2015 GROUP A PROPOSED CHANGES TO THE I-CODES MEMPHIS COMMITTEE ACTION HEARINGS

April 19–28, 2015
Memphis Cook Convention Center
Memphis, Tennessee

FIGURE 1

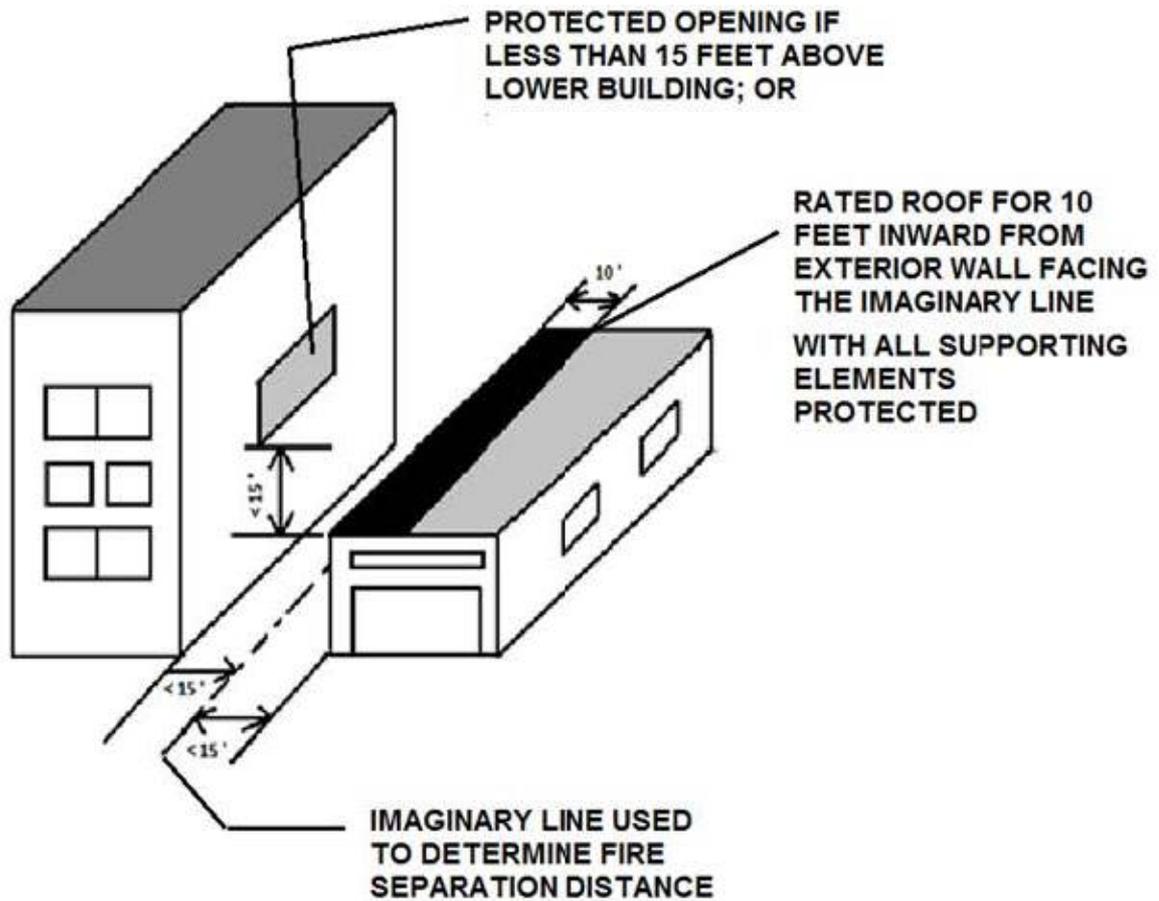
Both scenarios, an imaginary line and a real property line, have identical requirements of Table 602 for fire resistance based on fire separation distance, Table 705.2 for projections, Section 705.5 for exterior walls based on fire separation distance, Section 705.8 for exterior wall openings, Section 705.8.4 for mixed openings and Table 705.8 for exterior wall openings based on fire separation distance. Then we arrive at Section 705.8.6, for vertical exposure. This is the section that creates the conflict between imaginary lines and real property lines.

FIGURE 2

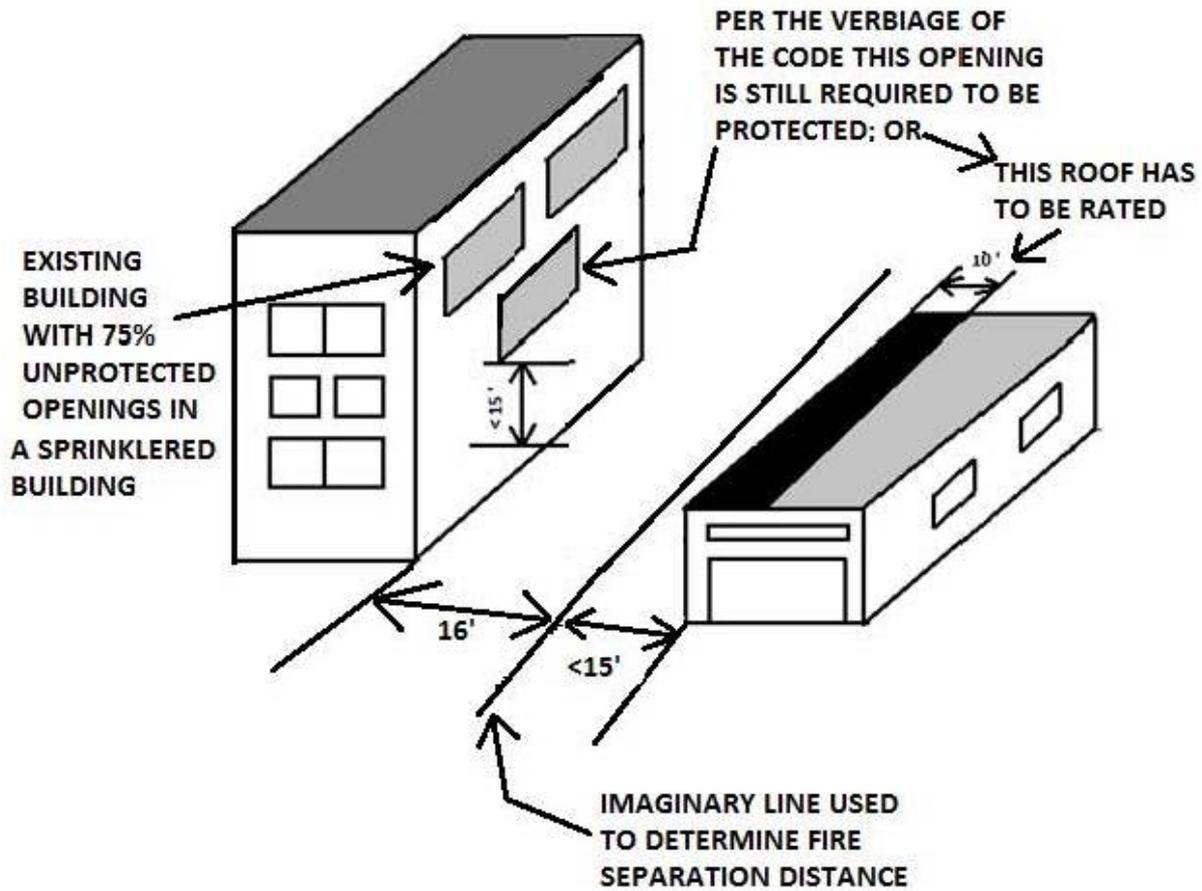
only applies if the lower building has a fire separation distance of less than 15 feet. One could have an existing building that had up to 75% of openings in the exterior wall,

FIGURE 3

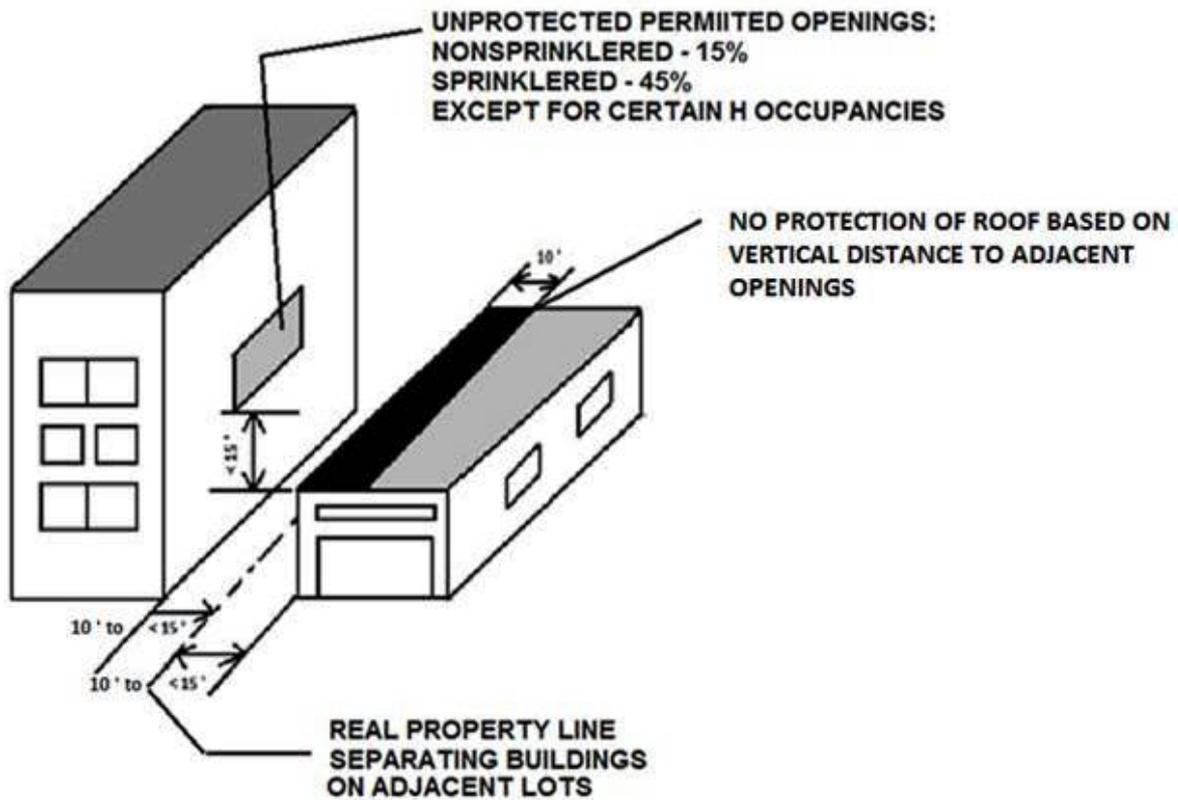
and another building was proposed to be constructed on the same lot 30 feet from it, one could place the imaginary line so the proposed building had a 14 foot fire separation distance and the taller one with the openings had a 16 foot fire separation distance the openings could remain unprotected in a non sprinklered building. But because of the code language, any opening that was less than 15 feet vertically above the adjacent roof would still be required to be protected because of the provision of measuring the fire separation distance for the lower building. Infact, you could have a much larger fire separation distance for the taller building but if the lower one was less than 15 feet, you would still have to protect to openings within the 15 foot range due to the absence of any fire separation distance for the building with the openings. Replacing the imaginary line with an actual property line,

FIGURE 4

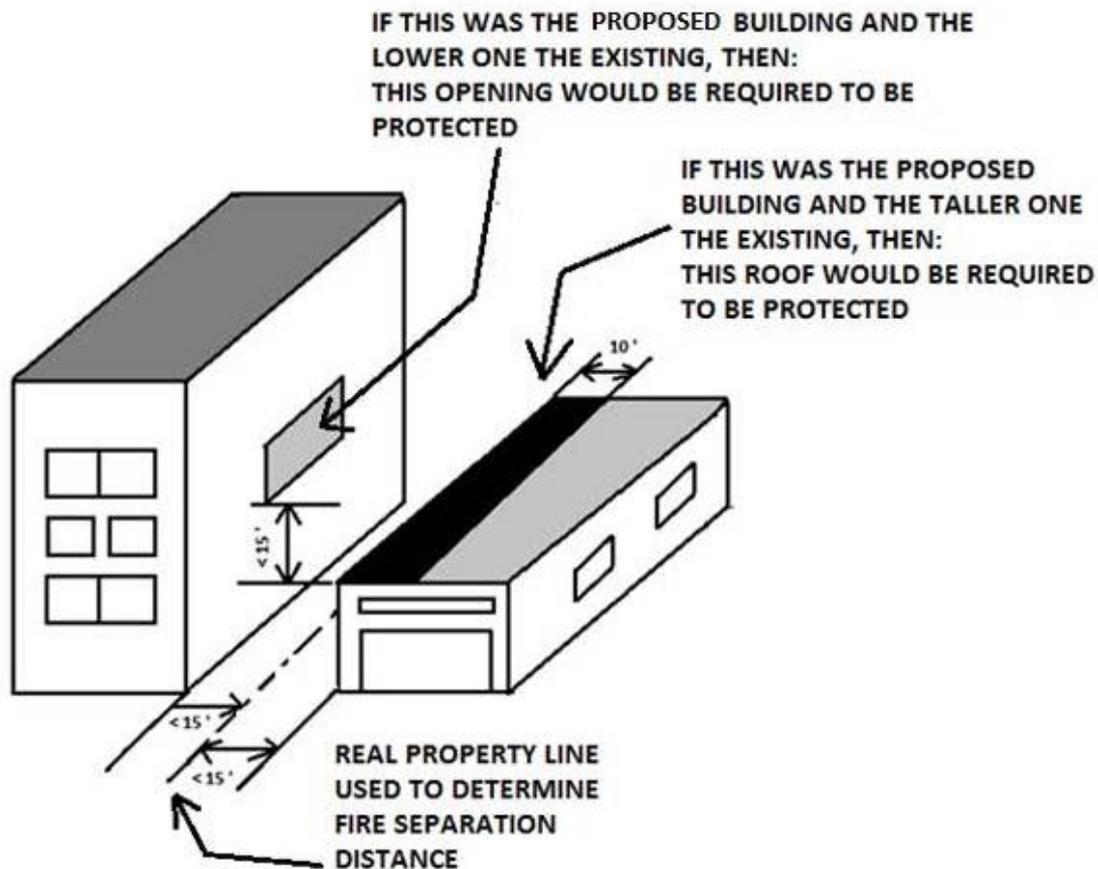
Statements from the Fire Safety committee in previous code hearings on this section were that you couldn't compare the two scenarios simply because with a property line you would have different owners and the buildings would not be constructed at the same time and how could you make two owners agree on which one does what, or how could you make an owner of an existing building retroactively modify a once code conforming building? I contend that you can relate them quite simply. If an existing building has less than a 15 foot fire separation distance to a property line, and another building is proposed on an adjacent lot with less than a 15 foot fire separation distance to the same property line, and there were one or more openings in one of the buildings that were less than 15 feet above the roof of the other building then Section 705.8.6 could be theoretically applied. The newer proposed building would have to have either a fire-rated roof or protected openings dependent upon whether it was the higher building or the lower building.

Example 1

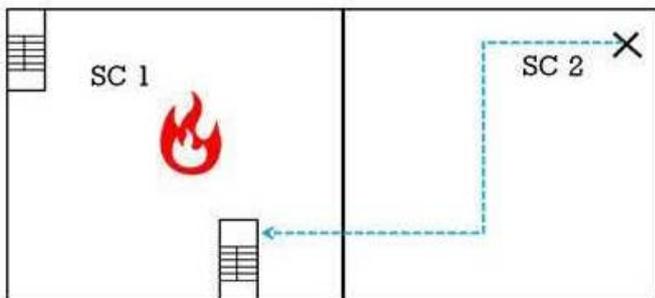
The proposed language would require that one of the stairs be located in smoke compartment 2, or, that the floor plate be rearranged to create access to two adjacent smoke compartments from compartment SC2.

Example 2

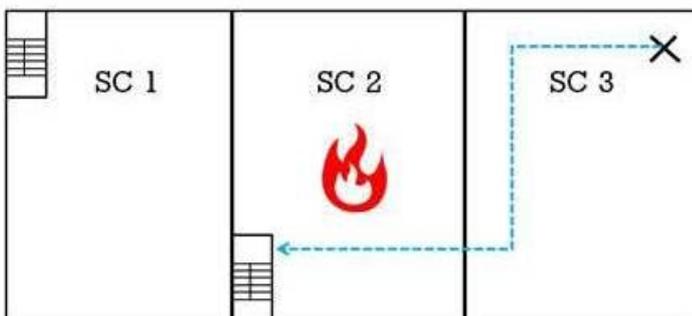
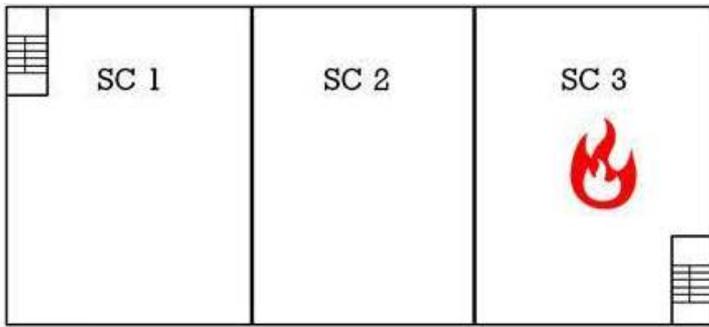
There is an easy fix to this problem: relocate the stair to smoke compartment #3 (see Example 3). That way, smoke compartments 1 and 3 have access directly to the stair, and smoke compartment #2 has access to at least two directly adjacent smoke compartments.

Figure 1

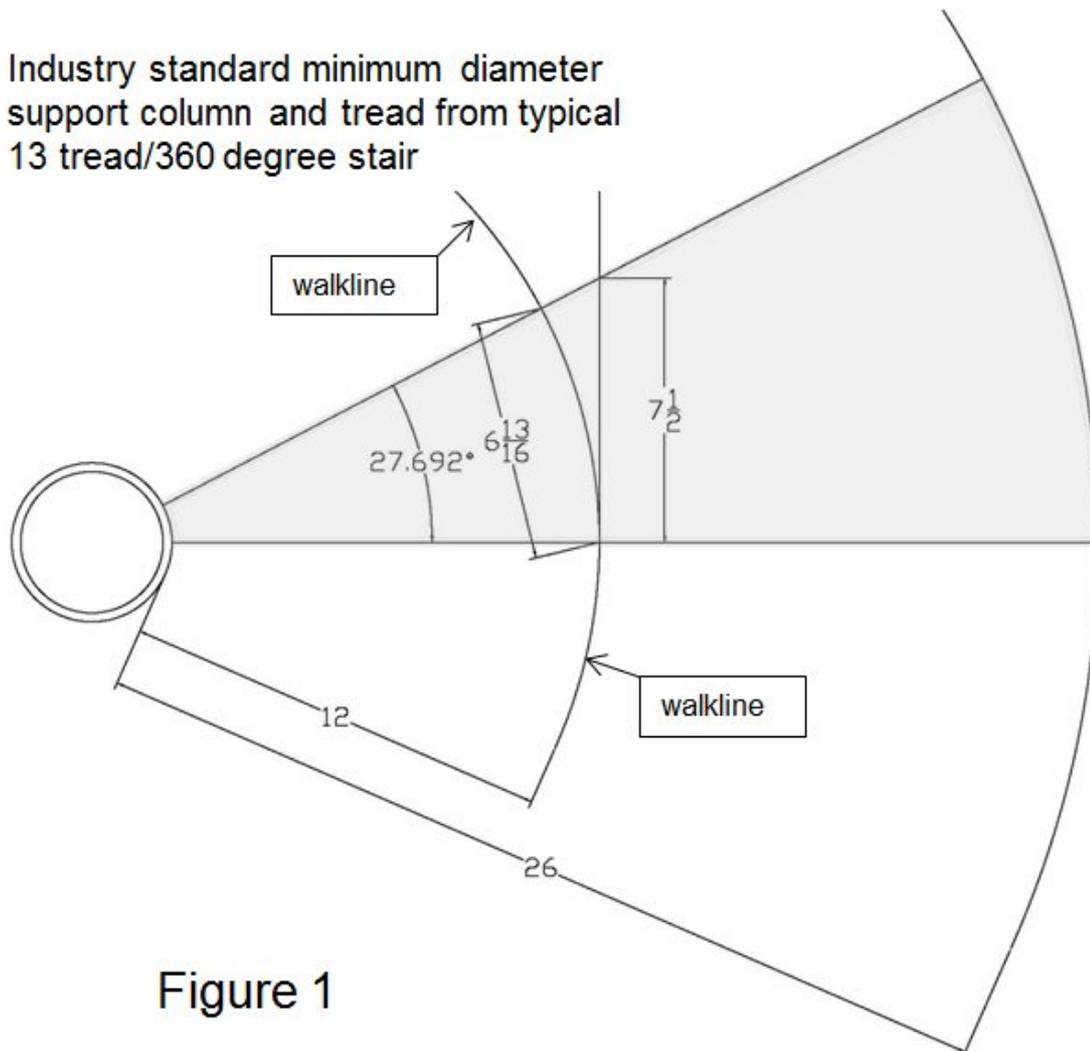
Winder tread depth is measured "...between the vertical planes of the foremost projection of adjacent treads at the intersections with the walkline...". The change in the method of measurement results in a smaller dimension, for the same tread, that is 3/4 inch smaller tread depth as illustrated in figure 1. The figure also illustrates the elements of spiral stair tread geometry. What is critical to understand is that if the code is not changed, each tread in the typical spiral stairway would need to be increased by 3/4 inch from the longstanding accepted practice.

Figure 1.A

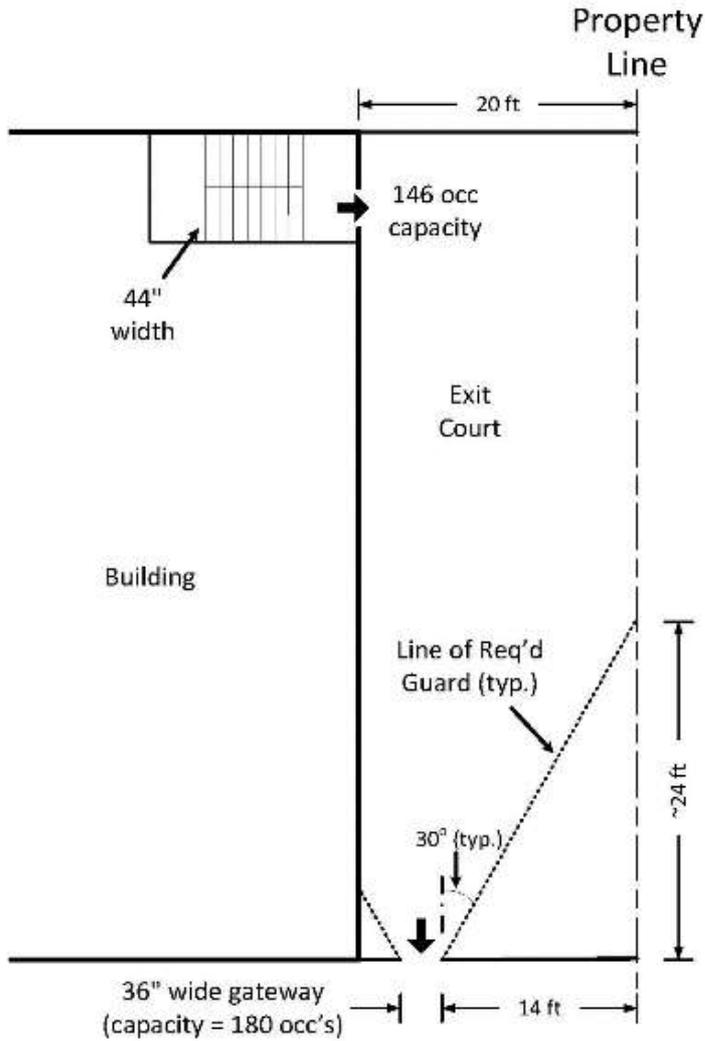
Figure 1.A shows an example of how the current code can be interpreted. A stair with the minimum 44-inch width required by the code ($\text{capacity} = 44/0.3 = 146$ occupants) discharges into a 20-foot wide exit court. The exit court has a 36-inch wide gateway at the front property line ($\text{capacity} = 36/0.2 = 180$ occupants). The current code can be interpreted to require the width to be reduced by guards at 30 degrees as shown in the figure. If one interprets the code to say that the guard must extend from the reduced section (the 36" gateway) to the widest point of the court (20'), and taking into account a 3-foot offset of the gateway, the result is a guard that extends to a point approximately 24 feet from the front property line.

Figure 1.B

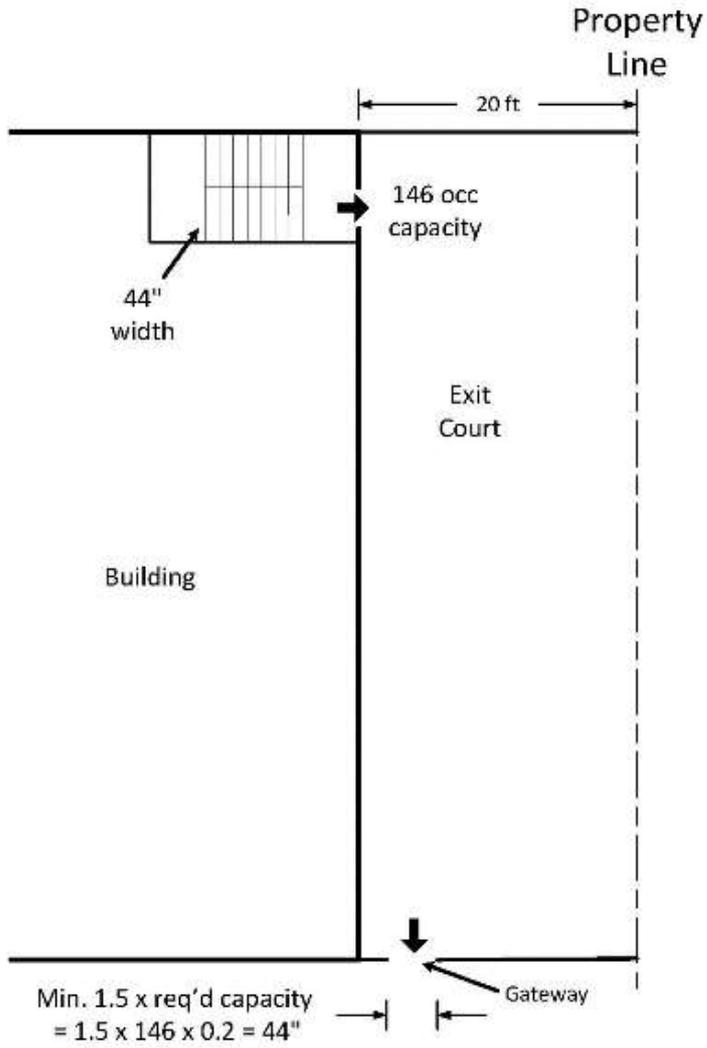
Figure 1.B shows the results if the designer opts for alternative being proposed. The gateway is now required to be 44 inches wide, but the guard is no longer required.

Figure 2.A

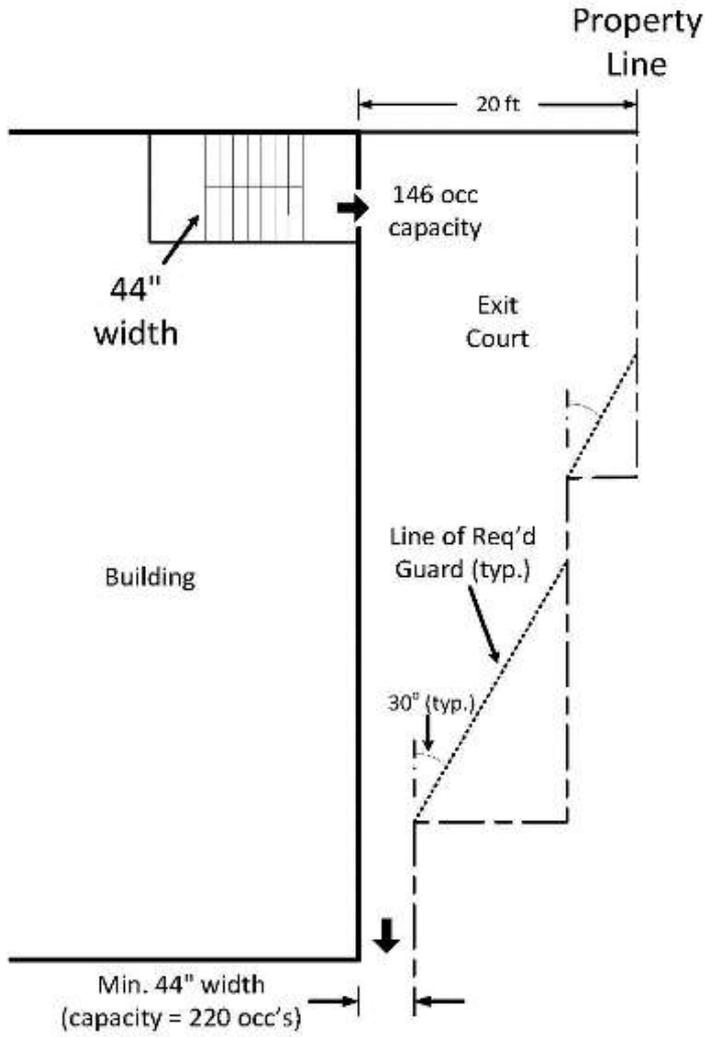
Figure 2.A depicts an exit court that reduces in width along its length and opens directly to the public way (no gateway). The same occupant load is being served by the exit court as in Figure 1.A. In this case, the code dictates a minimum 44 inch width for the exit court. The current code would clearly require the guards as shown.

Figure 2 – Effects of Water Temperature on Legionella Bacteria
 (Source: www.LegionellaPrevention.org)

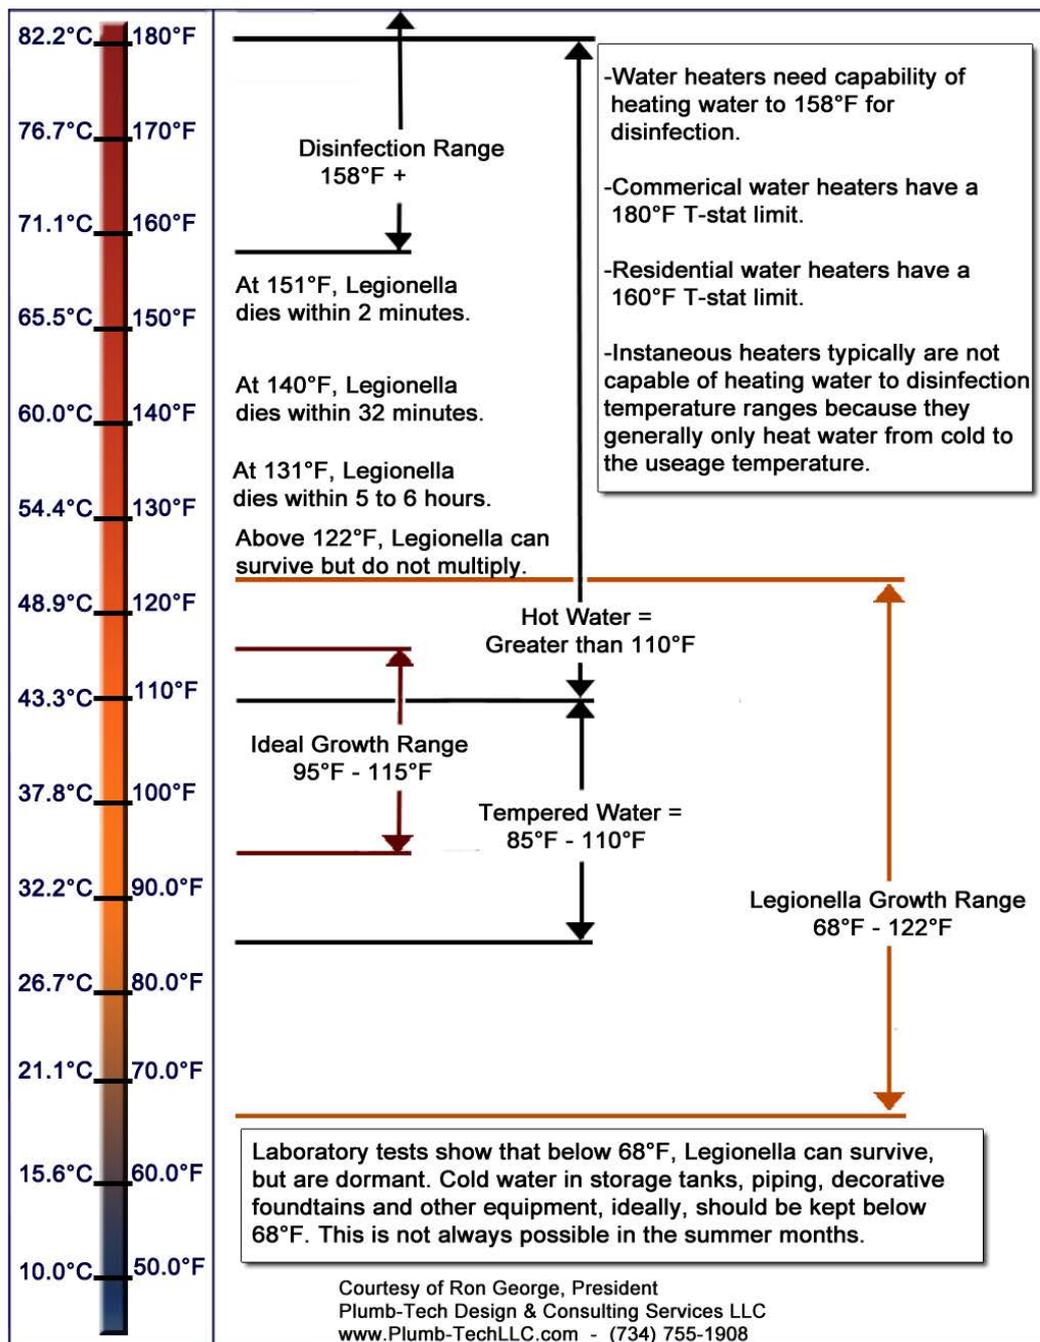
There have been numerous web sites, radio spots, print materials and other well intentioned people that suggest turning the water heater down to 120 degrees Fahrenheit to save energy and they usually discuss the added side effect of minimizing scalding. These suggestions are wrong for many reasons because the thermostat on the water heater cannot accurately control the outlet temperature of the water heater, Low storage temperatures also create a shortage of hot water, low storage temperatures can allow condensing conditions in heaters that are not designed for condensing which can lead to heat exchanger corrosion and it creates storage temperatures that are ideal for legionella bacteria growth. This is another example of energy conservation practices making a hot water system less safe. Safety should trump efficiency! There are other ways to prevent scalding without turning down the water heater thermostat. I have also heard of many healthcare facilities eliminating hot water tanks and installing instantaneous water heaters in a misguided effort to minimize Legionella bacteria growth in hot water tanks. It's not the tank it's the storage temperature. This is reaction to a problem that often creates other problems. (See Figure 2)
